GCC Rio Grande Inc.

Response to Regulatory Agency Comments:

Quarry 1 As-Built Report

June 11, 2024

Figure 1. Watershed Area vs Peak Discharge for the 100-Year, 24-Hour Storm

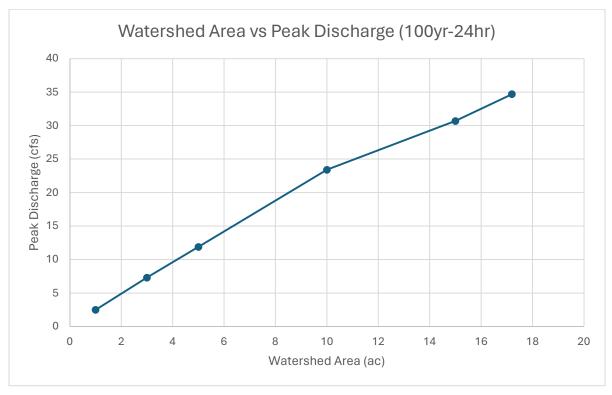
What rain event was the permanent stormwater channels constructed for? Please provide information on why this was chosen. We require at a minimum it can withstand a 24 hour – 100 year rain event. If this is the case, please provide detail on how that was accomplished with the constructed permanent stormwater channels that were constructed and why the width and length will hold that event.

Peak discharges for the selected watershed sixes were plotted demonstrating that peak discharge for the 100-year, 24-hour storm event increases almost linearly for this range of watershed areas (Figure 1).
